Location:	Lake Merritt BART Transit-Oriented Development (TOD) at 51 9th Street (Block 1) and 107 8th Street (Block 2).
Assessor's Parcel Number(s):	APNs: 001 016900100 and 001 017100200.
Proposal:	1. Amend the Conditions of Approval to allow for phased submittal of the PX and PZ Permit for Phase I of development. 2. Amend the Tentative Tract Map to create a vertical division of the Paseo resulting in a subterranean parcel containing the BART tunnel.
Applicant:	East Bay Asian Local Development Corporation (EBALDC)
Contact Person/ Phone Number:	James Perez /510-512-2444
Owner:	San Francisco Bay Area Rapid Transit District (BART)
Case File Number:	PLN20108-R01
Planning Permits Required:	Revision to existing entitlements for Planned Urban Development (PUD), the Phase I Horizontal Final Development Plan (FDP and Tentative Tract Map).
General Plan:	Central Business District (CBD)
Zoning:	D-LM-2, D-LM-4, Height Area LM-275

CITY OF OAKLAND PLANNING COMMISSION

Case File: PLN20108-RO1
Applicant: James Perez
Address: 51 9th St & 107 8th St
Base Zones: D-LM-2, D-LM-4
Combining Zones: S-13, S-14
Height Area: LM-275

REVISED VESTING TENTATIVE TRACT MAP NO. 8560 (BLOCK 1) AND 8577 (BLOCK 2) TR

ATTACHMENT D

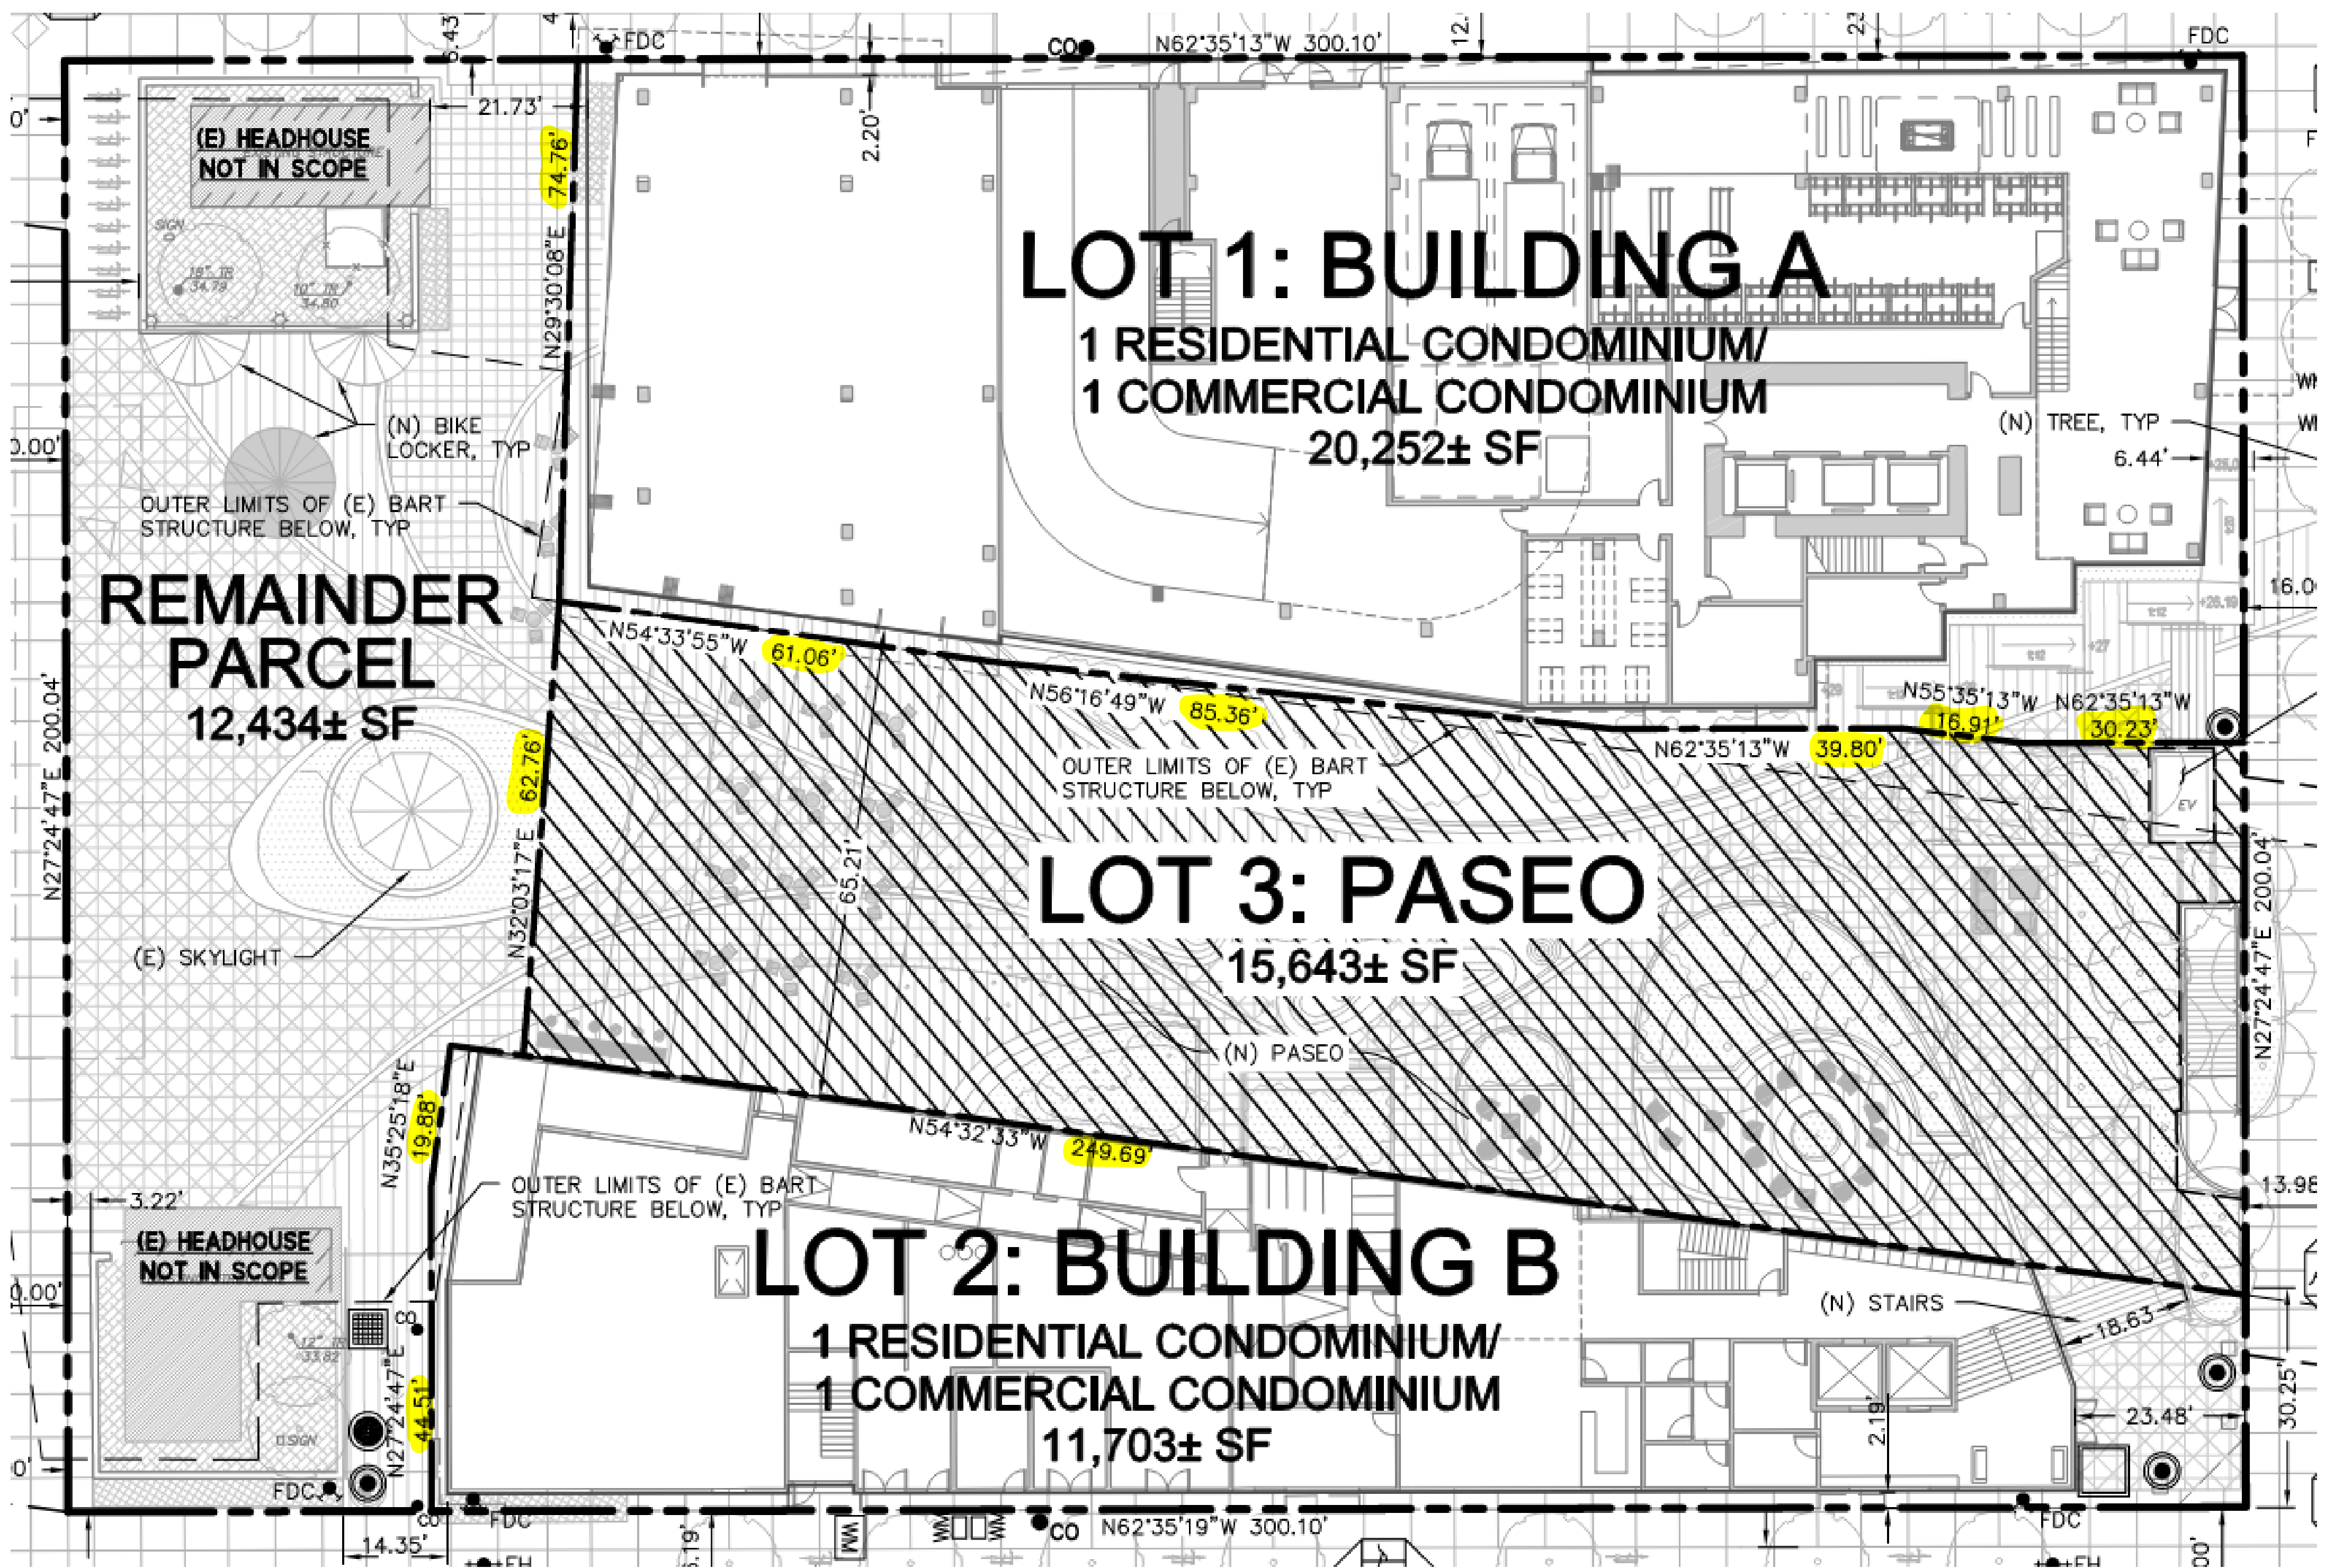
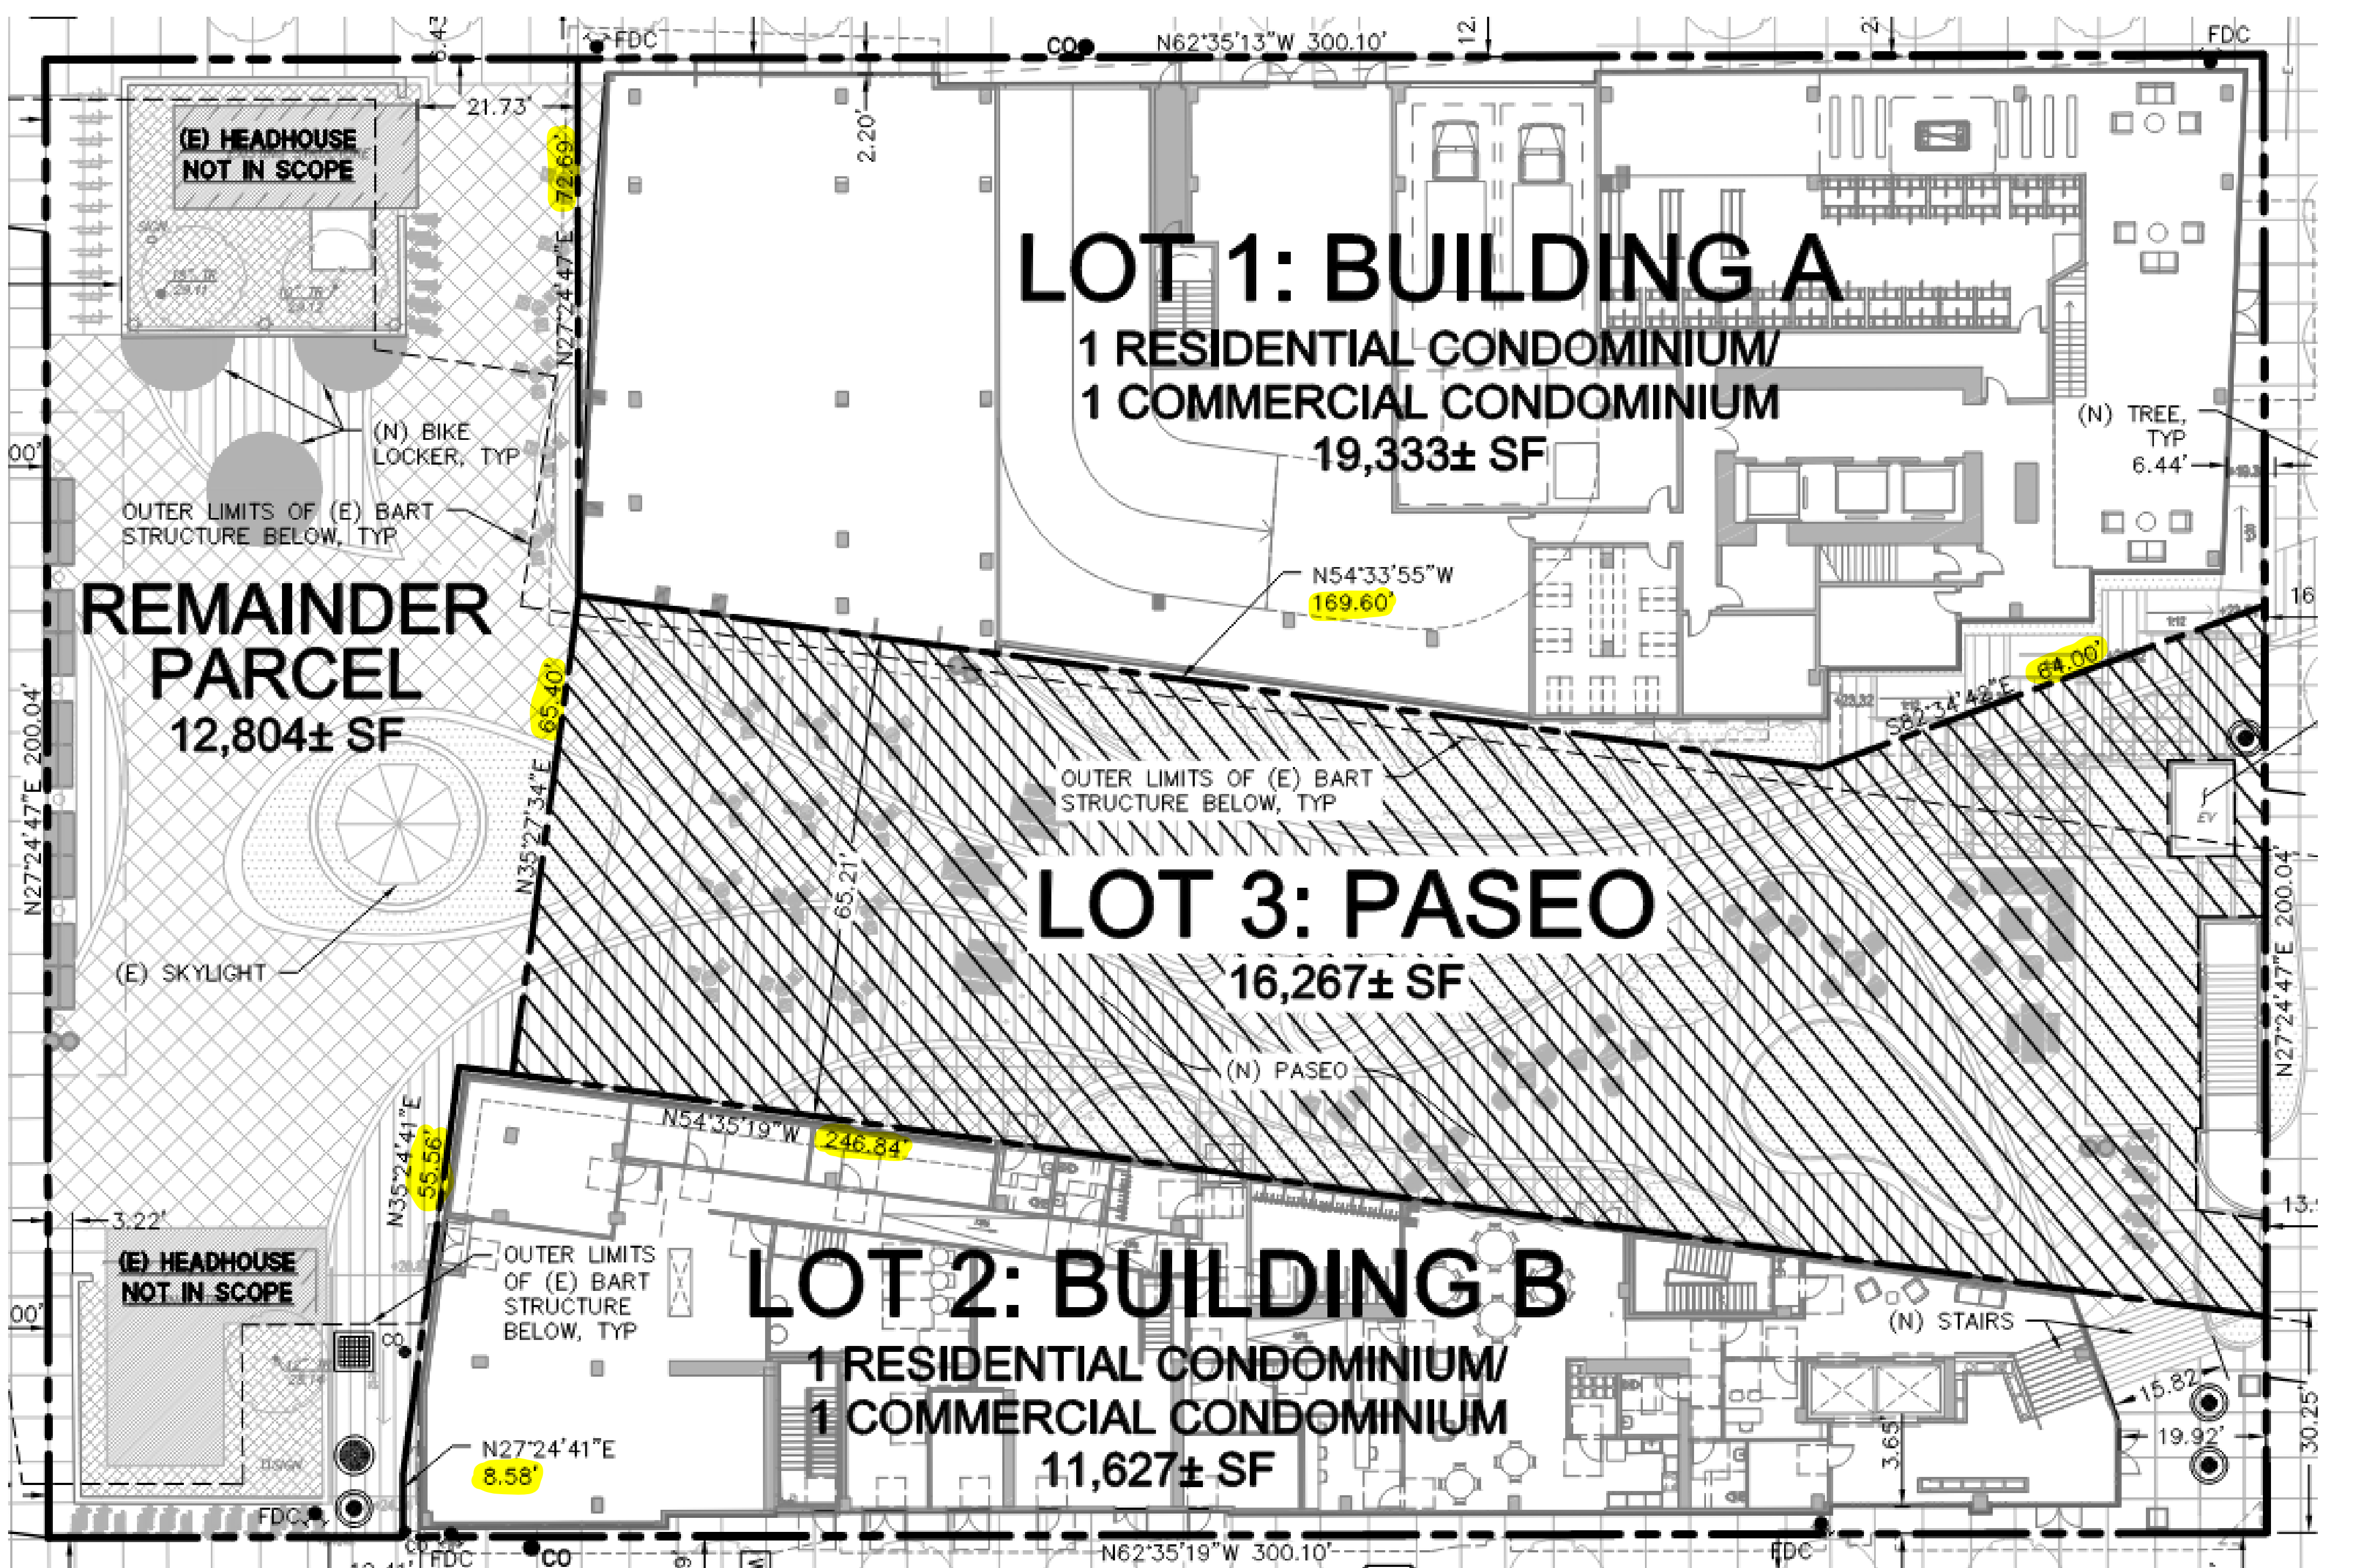
3. Amend the Tentative Tract Map (TTM) to conform lot lines and parcel sizes with the lot configuration approved by the Planning Commission during FDP review.

After approval of the TTM as part of the PUD review, BART further analyzed existing site conditions and determined that the lot configurations on the tentative map resulted in BART substructures projecting into the future residential properties. BART requested adjustment of the FDP map to eliminate this projection. The change to the map resulted in a reconfiguration between Lots 1, 2 and 3 and the remainder parcel. The change in the parcel configuration is shown in **Attachment D**, which compares the PUD map and the FDP version. The FDP was approved with this correction, however the TTM itself was not amended concurrently so the approved TTM still has the configuration shown on the PUD map. The proposed TTM shows the conformed lot lines and parcel sizes and as amended would resolve this conflict.
